ADDENDUM

No. 2

**Humanities Building Central Plant
Cooling Tower Replacement, Rockville Campus**

Project:	MC RV HU (BLDG No. 208) Central Plant Cooling Tower Replacement	Date:	10/28/2019
		Reference:	
Title:	Addendum #2 Drawing Narrative	BKM Project No:	19104.01

M0.01

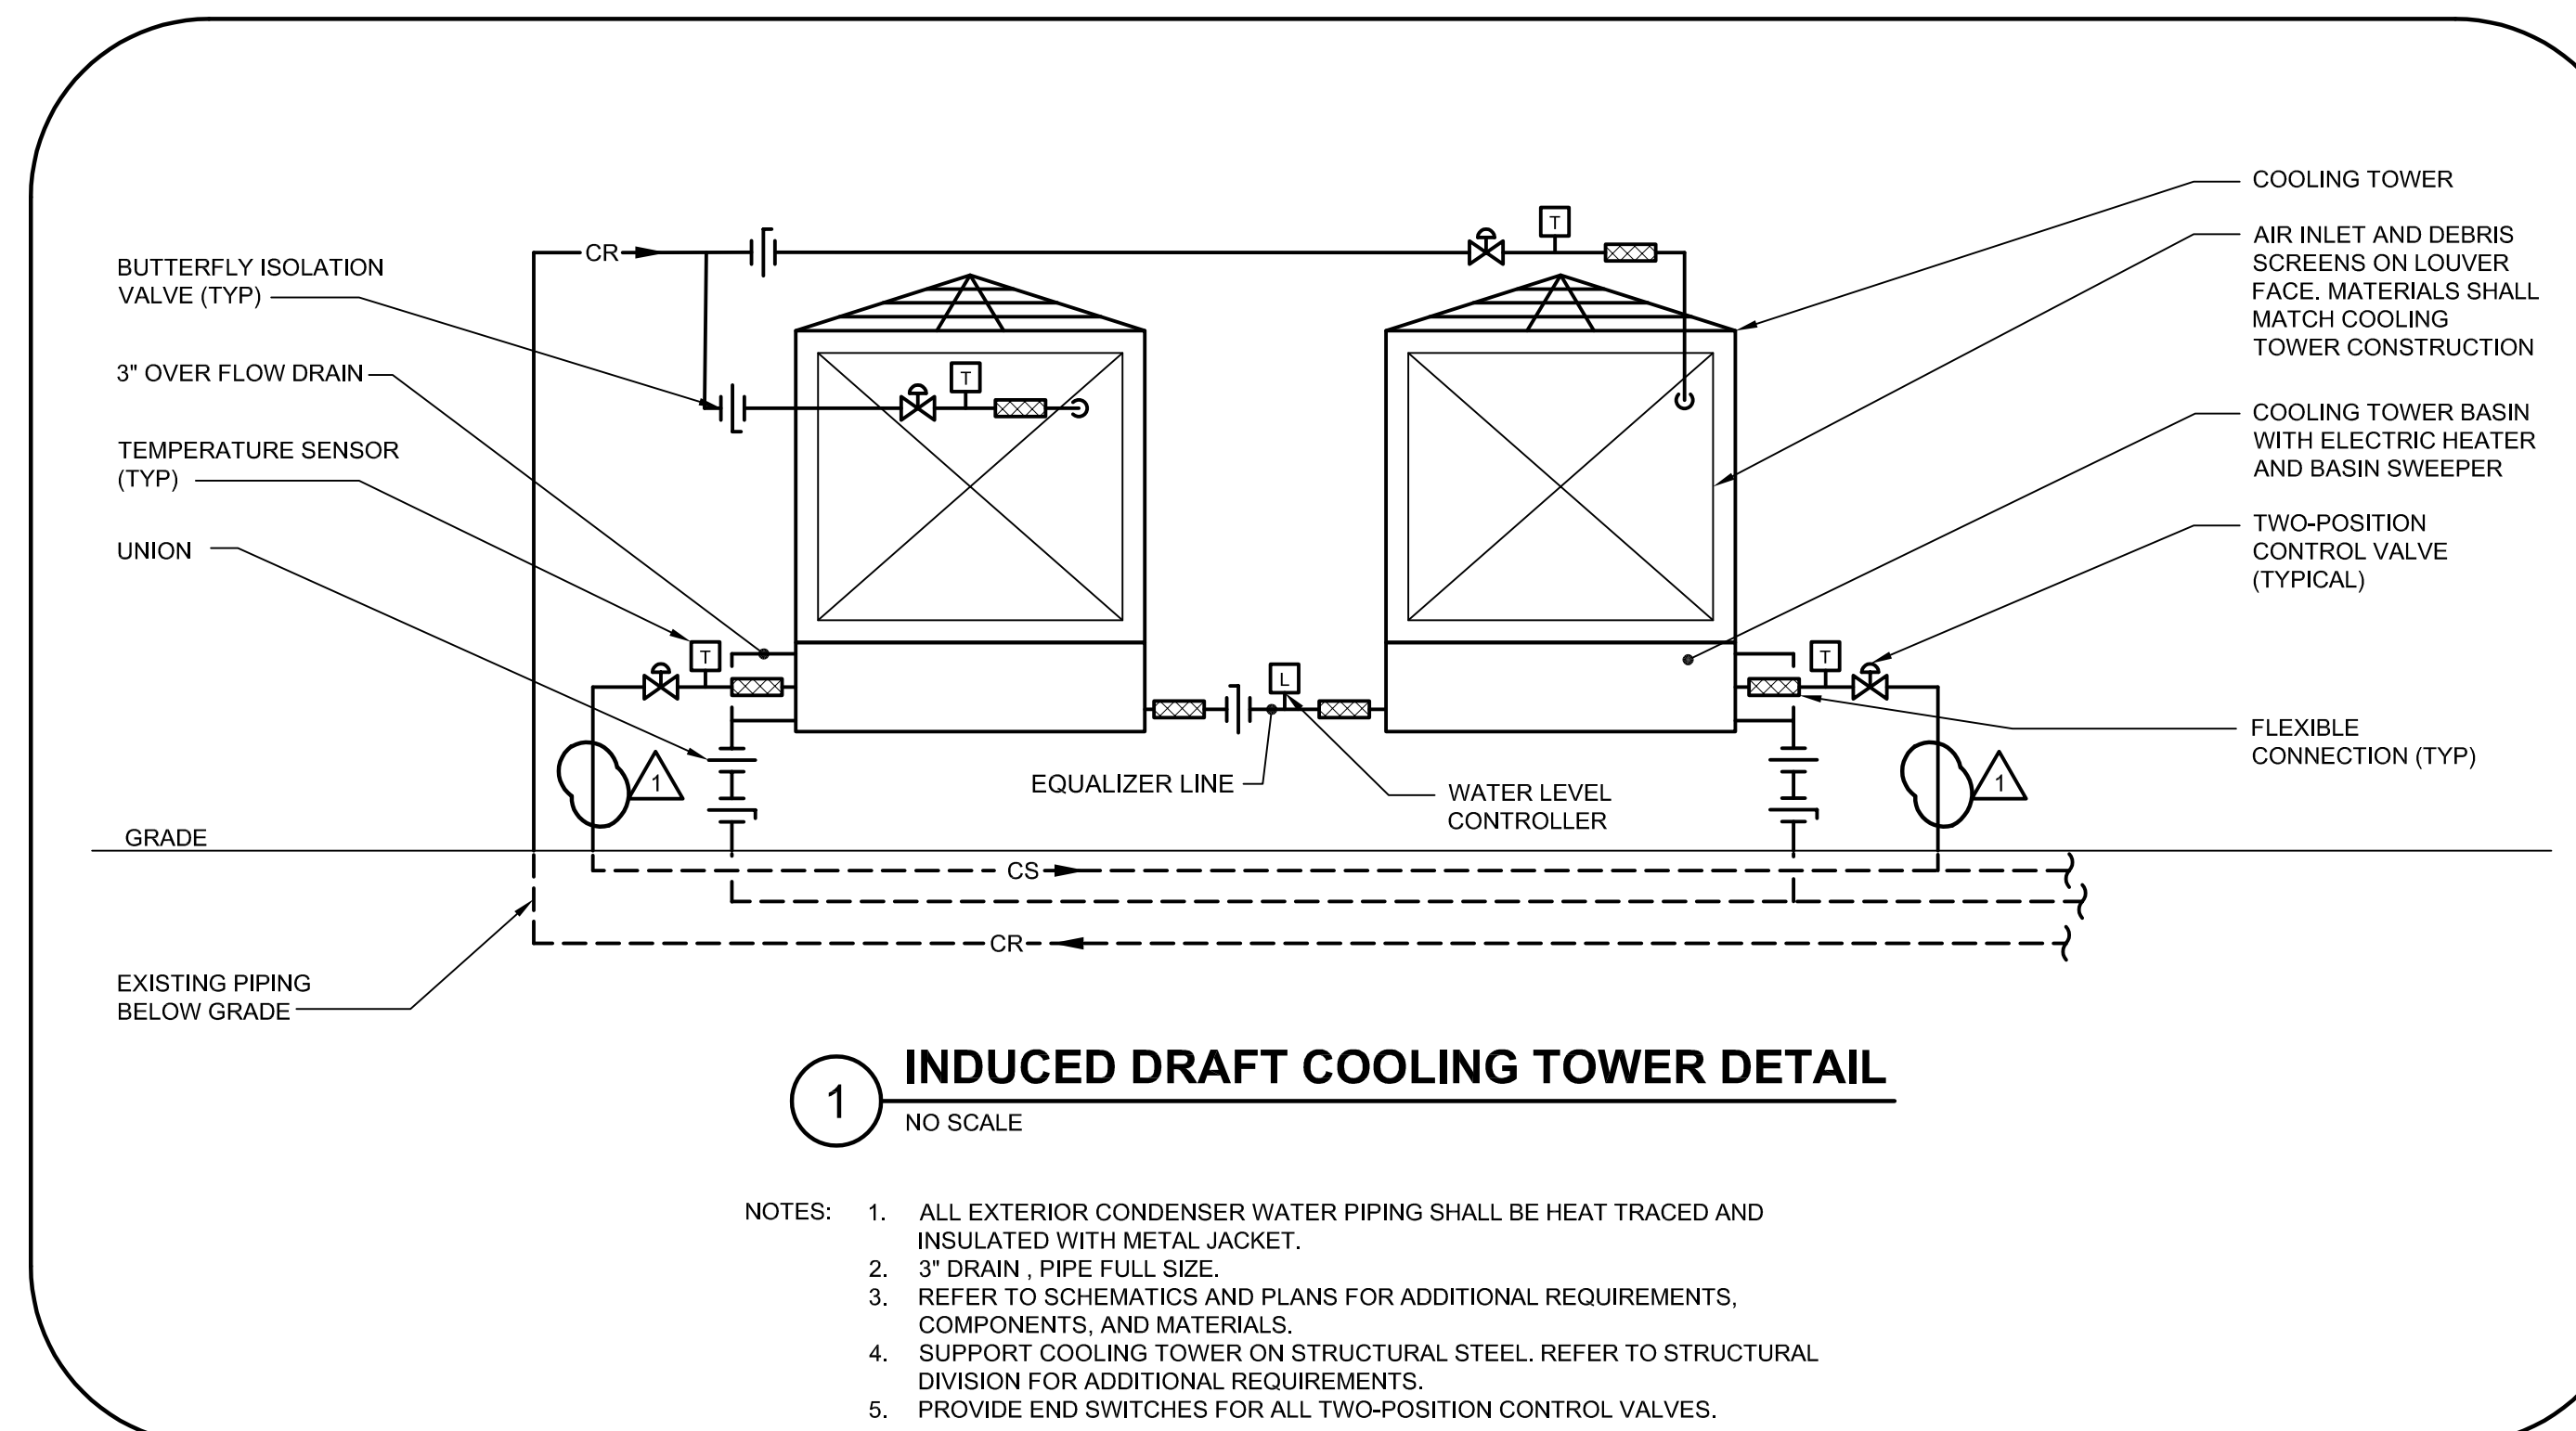
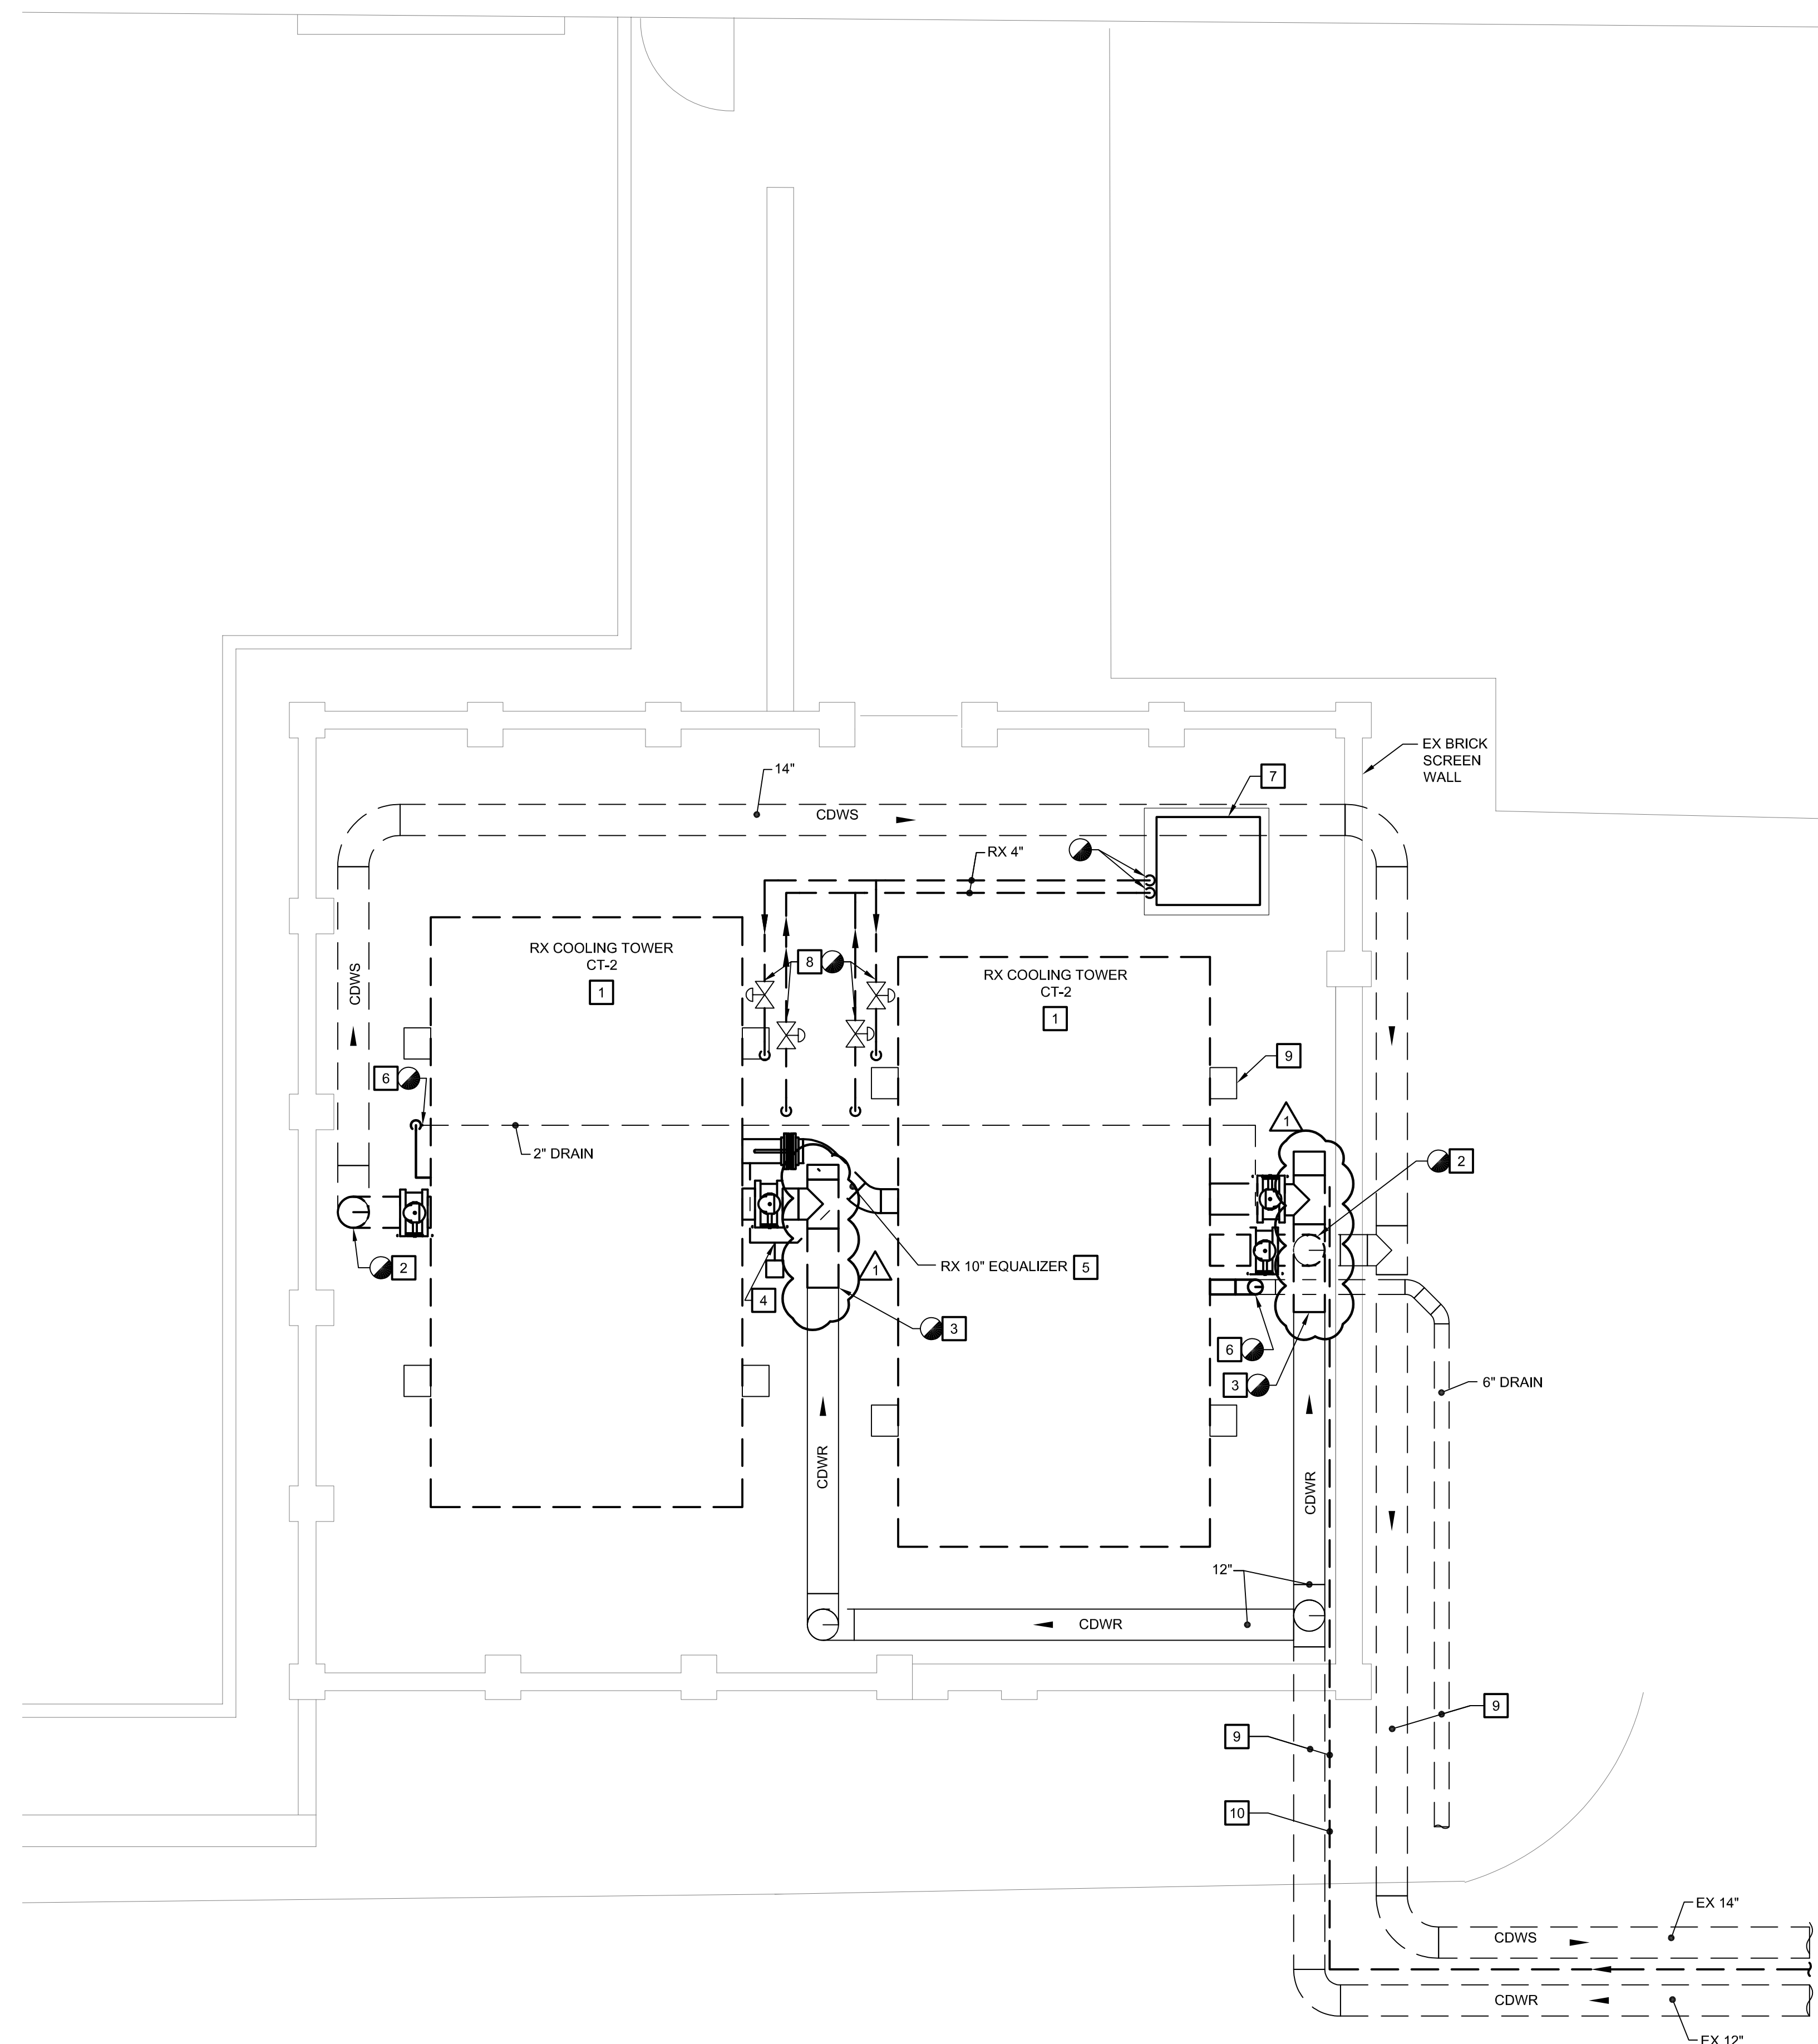
- Answer: See addendum #2 on M0.01 and M1.01. Additional manual butterfly isolation valves shall not be required on cooling tower outlet piping. Provide control valve and flexible connection.

M0.01 "Mechanical Legend, Abbreviations, General Notes, Schedules and Details"

- Manual butterfly (shut off) valves have been eliminated from the cooling tower outlet piping.

M1.01

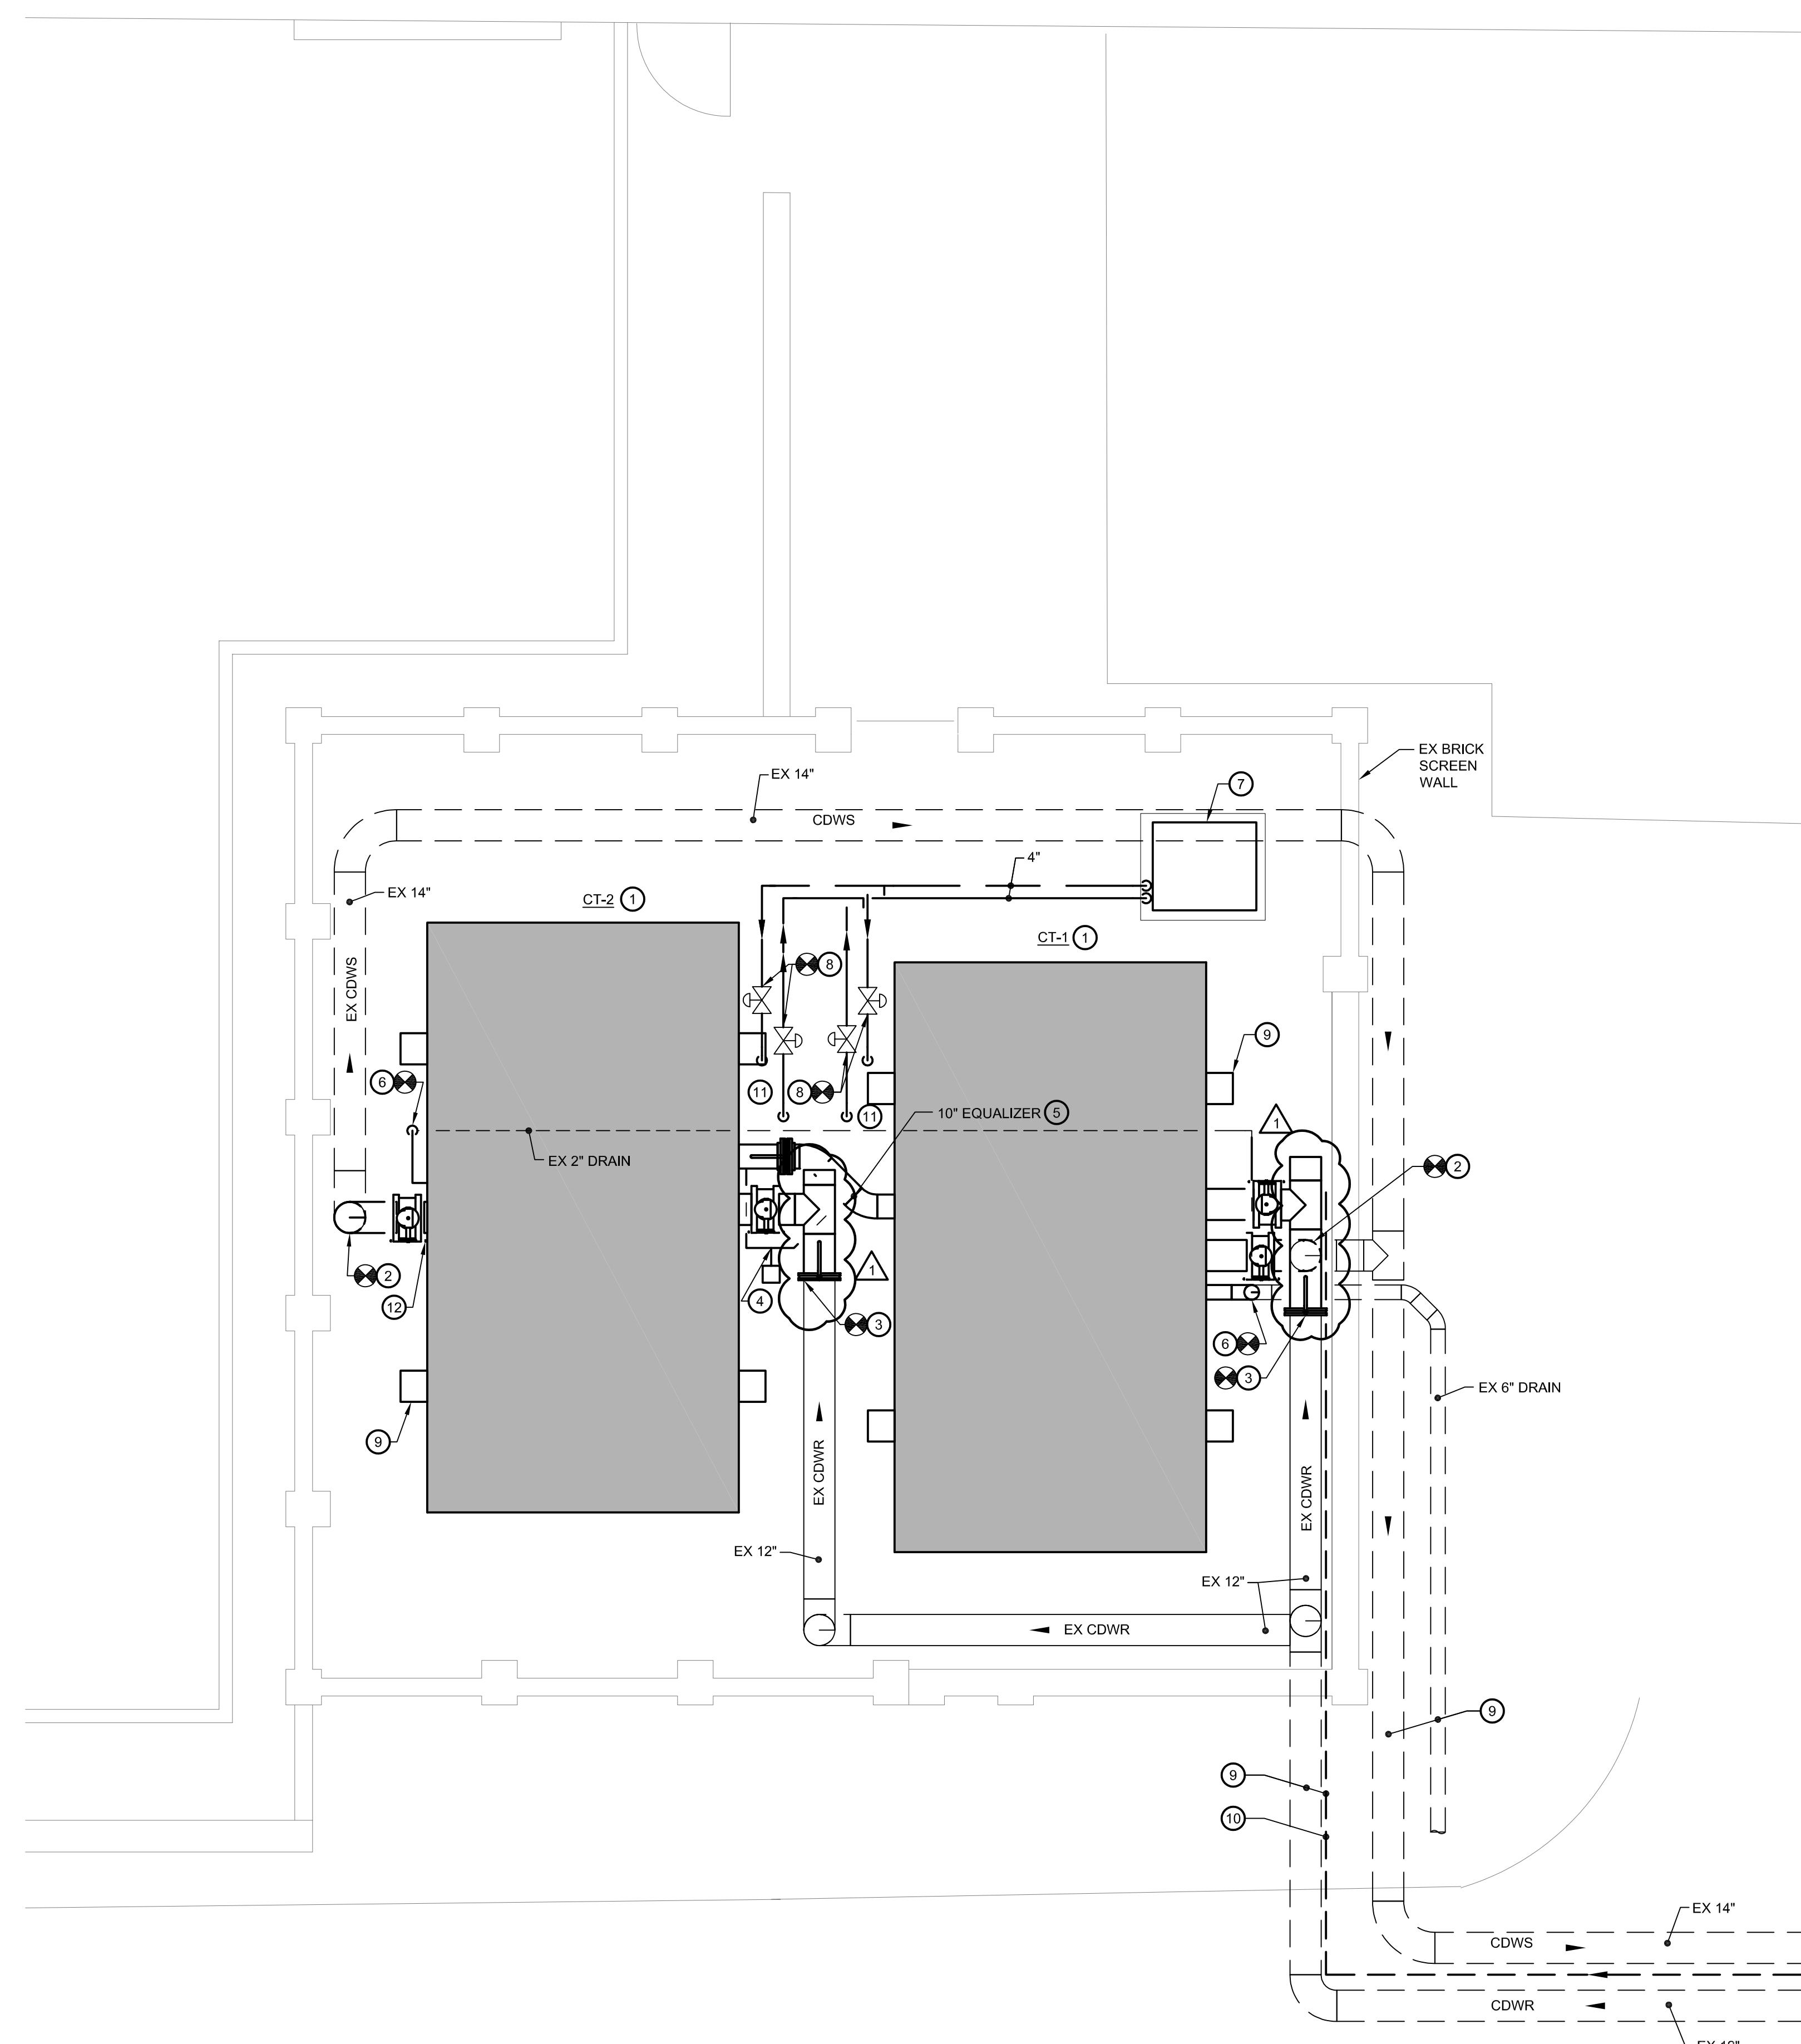
- Answer: New PVC Basin Sweeper piping shall be provided from the existing side stream separator to cooling tower basin connection. The existing side stream separator control valves shall be installed in the locations indicated on M1.01.

M1.01 "Part Site Plan – Mechanical – Demolition and New Work"

- Manual butterfly (shut off) valve has been added to the condenser water return piping to match the detail on M0.01.
